## The Hows, Whys and Fixes for Pegasus "Jitter"

Recent investigations into the reasons and possible cures of Pegasus screen Jitter have revealed that there are at least 4 distinct causes. This report explains the theory behind these causes and suggests some modifications to erradicate the jitter.

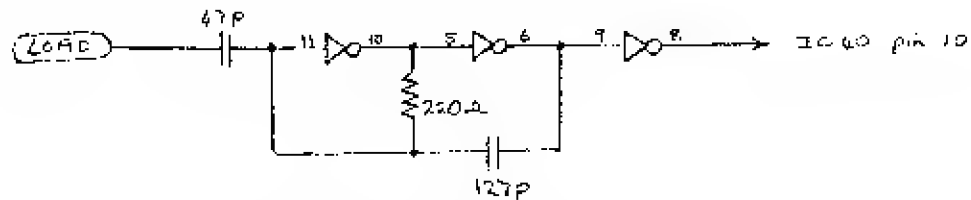
The frame rate for the video is initiated by a signal derived from the mains; Once the frame is started, everything is locked to the processor clock. So while the picture information doesn't jitter with respect to HSYNC and VSYNC, the frames themselves do jitter with respect to each other. In other words the VSYNC signals are not regular. Sometimes they are  $X \times 64 \text{ us}$  (HSYNCS occur every  $64 \text{ us}$ ) apart and sometimes they are  $(X + 1) \times 64 \text{ us}$  apart. Normal TV sets have an oscillator which likes to lock to regular VSYNC pulses. It will infact lock to a frequency with a period somewhere between  $X + 1$  and  $X$  times  $64 \text{ us}$ . Then what you get is a picture sometimes slightly above and sometimes slightly below the true position. The cure is to use some kind of divider to derive your 50Hz from the processor clock, instead of the mains. The following mod uses one IC and some existing gates on the Pegasus board.

The 74LS20 gate has tracks running to it which must be cut.  
 The 74LS04 becomes free from a modification to the dot clock  
 oscillator which was given to us by G. Barbour of Christchurch.  
 This modification stops shimmer on the displayed characters  
 and stabilizes the oscillator frequency.

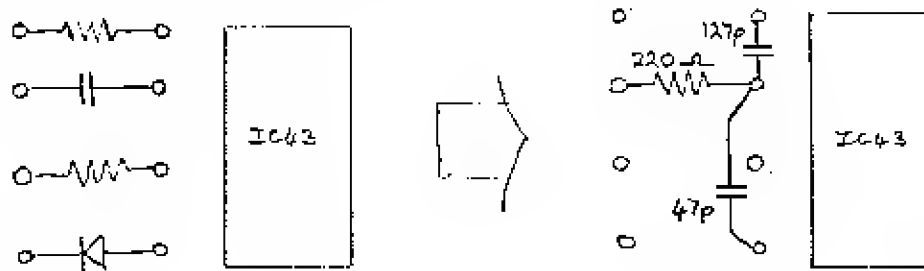
This modification only involves removing 4 components and  
 replacing them with 3 components as shown.

The IC43 gate at pins 13 and 12 is freed for use in the  
 4020 mod.

## Type 2 Jitter

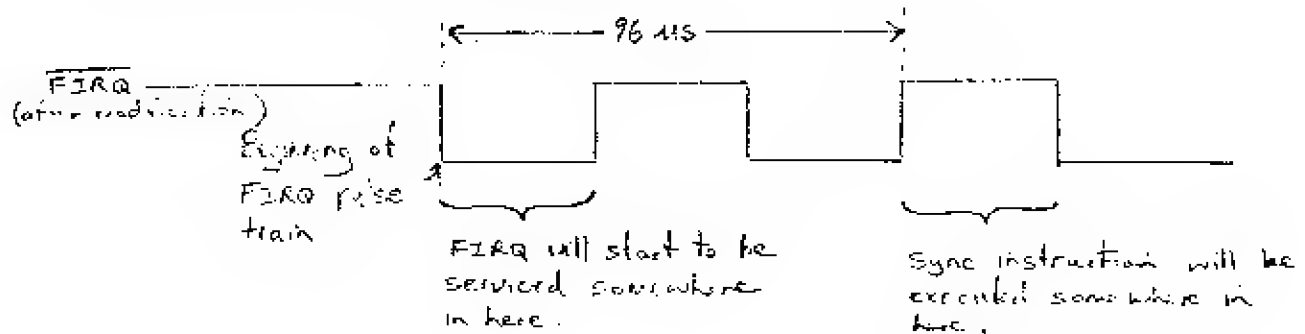
The FIRQ pulses generated by the existing Pegasus hardware are 8  $\mu$ s long. The 6809 chip however only checks the FIRQ pin after each instruction. Since 6809 instructions can take up to 20  $\mu$ s it is clear that it is possible for the chip to miss on FIRQ pulse. If it "sees" the following one then the whole picture will be 64  $\mu$ s too late i.e. one scan line too low on the screen. This causes jitter whenever programs with longish instructions are running.

The cure for Type 2 jitter is to take the FIRQs from the 74LS93 divider, IC7 pin 9. This is a square wave with 32  $\mu$ s each way. This modification also needs a new monitor version 2-3. The delays in this monitor are adjusted so that a) the picture is in the middle of the screen and b) the SYNC instruction is 96  $\mu$ s after FIRQ starts to be serviced. This ensures that the SYNC instruction is not executed while the FIRQ line is low, which would cause terrible sideways jitter.

From this drawing it can be seen that 32  $\mu$ s is the ideal length for the FIRQ pulse (which is active low) because it gives an equal mark space ratio square wave. If the FIRQ pulse were any longer, then the period in which the FIRQ line is high becomes correspondingly shorter and it<sup>is</sup> then possible for the SYNC instruction to occur while the FIRQ line is low, giving sideways jitter.

If the FIRQ pulse is shorter than 20  $\mu$ s it is possible for them to be missed by the processor. In fact the full 32  $\mu$ s is better because it allows the programmer to mask off FIRQs for two or three instructions if he wishes, without missing an FIRQ.

So 32 us FIRQs are used. The time from the start of servicing of the FIRQ to the SYNC instruction in the monitor is adjusted to be 96 us. Also since the new FIRQs are out of phase with the old ones, the monitor has its delay that positions the picture in the middle of the screen adjusted.

The actual modification is done by cutting the track to the 202 74LS32 pin 5 and jumping this pin to the 74LS93 pin 9 (IC7) and getting a version 2-3 monitor.

#### Type 3 jitter

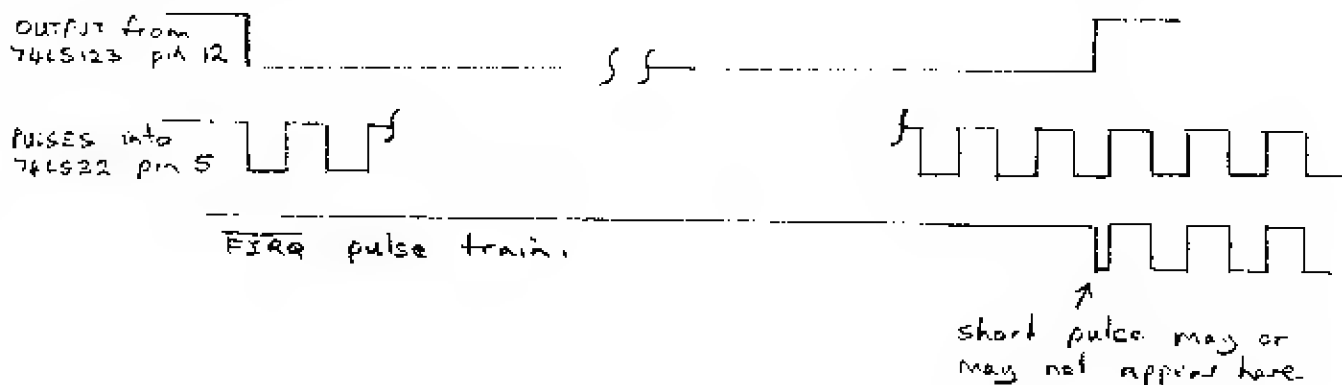
The timing from the VSYNC pulse to the start of the FIRQ burst of pulses is done by a 74LS123 one - shot. The delay is approx 3 ms, and since this is timed from an R-C network it cannot be set accurately. If the end of the delay comes during the time that the FIRQ pulse is low, then a small FIRQ pulse will be given to the processor before the burst of full length ones.

Since the pulse can be very short the processor may or may not "see" it. The 123 delay drifts with time and so the jitter will come and go.

The cure is to clock IC46 b with FIRQ pulses instead of E. This F/F is redundant as it is anyway. The existing track to the 74LS74 pin 11 (IC46) cannot be cut as it is underneath the IC. Instead it must be cut in two places and then 2 jumpers need to be put in.

Cut the track running from IC46 pin 11 to the system PIA pin 25 and also cut the track running from IC46 pin 11 just before the hole where it goes through the board and on to pin 3 of the 74LS04 oscillator. (IC43). Now join this hole back to the PIA pin 25. Now join IC46 pin 11 to the 74LS32 pin 5 (IC2). Note that this half of IC46 does not appear in the drawings but it is used in the circuit.

### Type 4 jitter

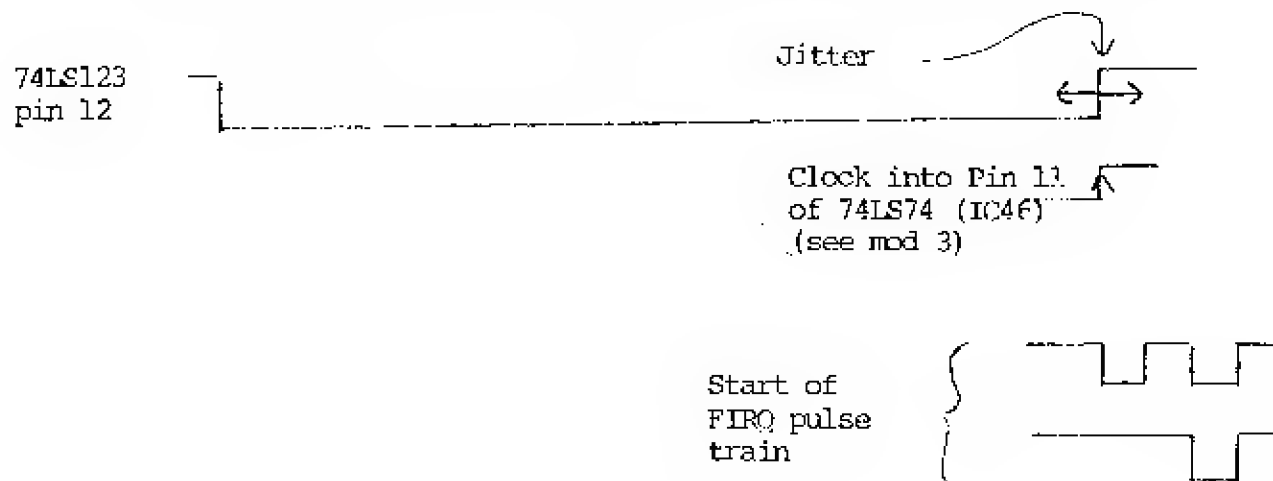
Type 4 jitter is again caused by the 74LS123. Using an oscilloscope it can be seen that a noticeable jitter occurs in the delay pulse whenever the Pegasus is running a program. When the trailing edge of the pulse falls on or near the clocking point explained for type 3 mod then the jitter in the 123 will cause the first FIRQ pulse to appear sometimes latter and sometimes earlier.

The only way to get round this is to bypass the 74LS123 altogether and use some pulses derived from the Type 1 jitter mod. (see the drawing for the 4020 mod). The existing track to 74LS74 IC6 pin 3 must be cut and taken to the spare nand gate as shown. This will give a picture nicely in the middle of the screen. (vertically)
